Pentium® II Processor Specification Update

Release Date: May 13, 1998

Order Number: 243337-014

Figure 1. UP Dual Ended Termination (DET)

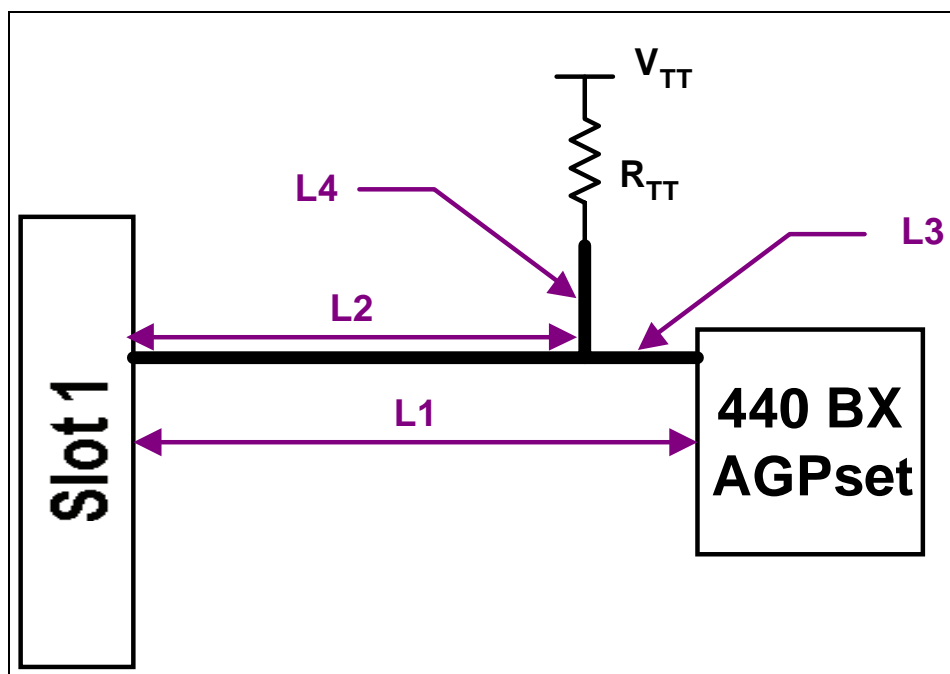
For UP-DET topologies (see Figure 1), the trace length $L1$ must be between 1.5" to 4.5" while using a 56Ω termination resistor.

Figure 2. DP Dual Ended Termination (DET)

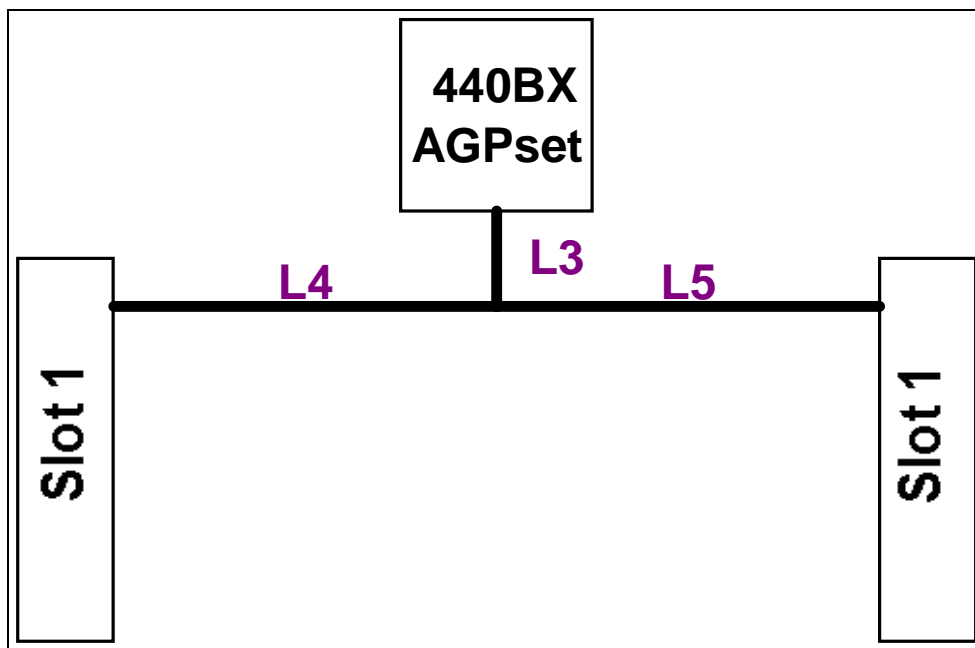
For DP topologies (see Figure 2) installed with a processor and a termination card, $L4 + L3$ or $L5 + L3$ must be less than or equal to 4.5". Additionally, for DP platforms with one processor installed, the termination card should be placed in the longer leg.

Figure 1. An Example of Micro-controller Driven Thermal Management

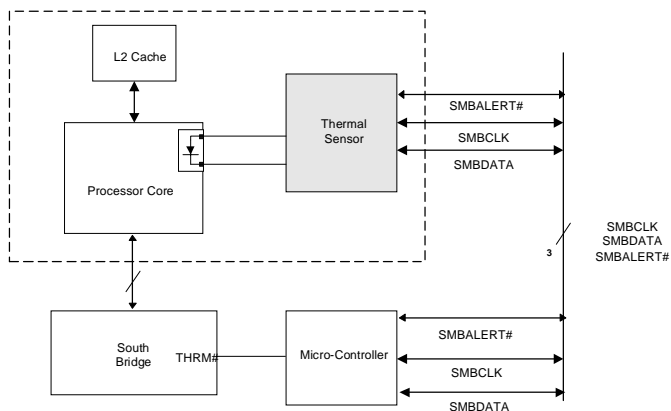
PROBLEM: The Mobile Pentium II processor and the Pentium II processor Mobile Module have a thermal sensor that monitors the processor core's temperature. Please note that desktop systems could have a similar thermal device. The thermal sensor asserts SMBALERT# if the processor temperature exceeds the temperature limits set in the Alarm Threshold Registers (T_{HIGH} , T_{LOW}). It also sets the corresponding Status Register bits to identify the cause of the interrupt. Figure 1 gives one example of the how the SMBALERT# signal could be used in a system.

Under the conditions described below, the thermal sensor incorrectly generates the SMBALERT# interrupt. *All* of the following conditions must be met to trigger a false interrupt:

Figure 2. Workaround Flowchart: SMBALERT#-Driven System

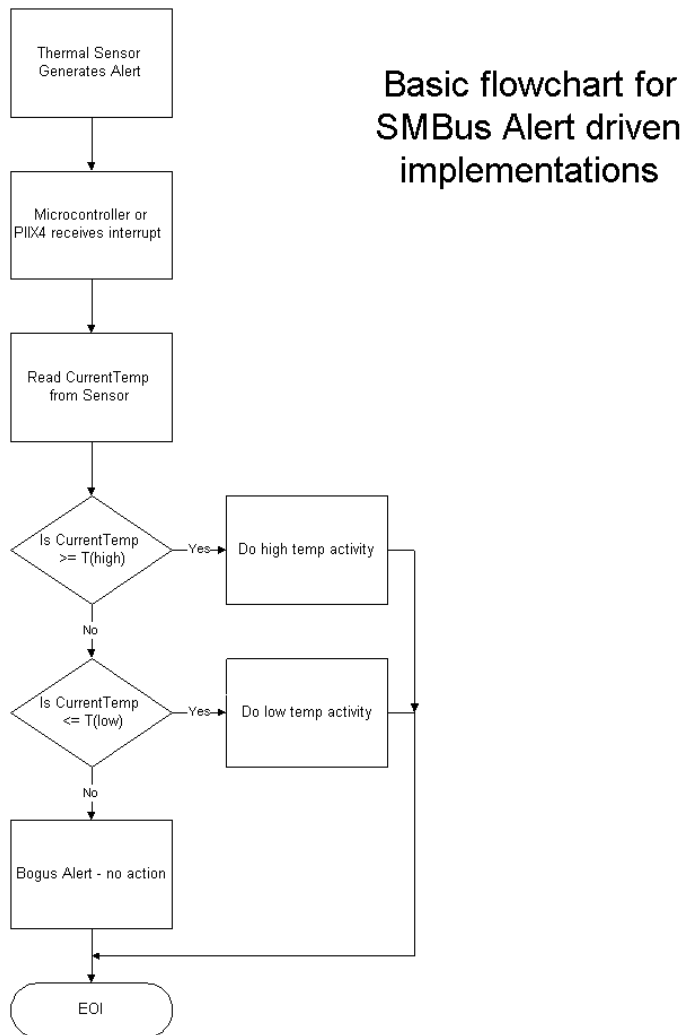
WORKAROUND: Three different (mutually exclusive) workarounds are possible:

1. Before servicing an interrupt from the thermal sensor, read and compare the processor thermal reading with the threshold limits (T_{HIGH} or T_{LOW}). Figures 2 and 3 provide basic flowcharts for the implementation of this workaround in an interrupt driven system.
2. If the firmware implemented polls the Status Register only, then before taking any action, re-read the temperature register and do a comparison with the alarm threshold limits (T_{HIGH} or T_{LOW}) to determine if the value is actually still within the temperature window.
3. Use a temperature polling scheme to monitor the processor temperature.
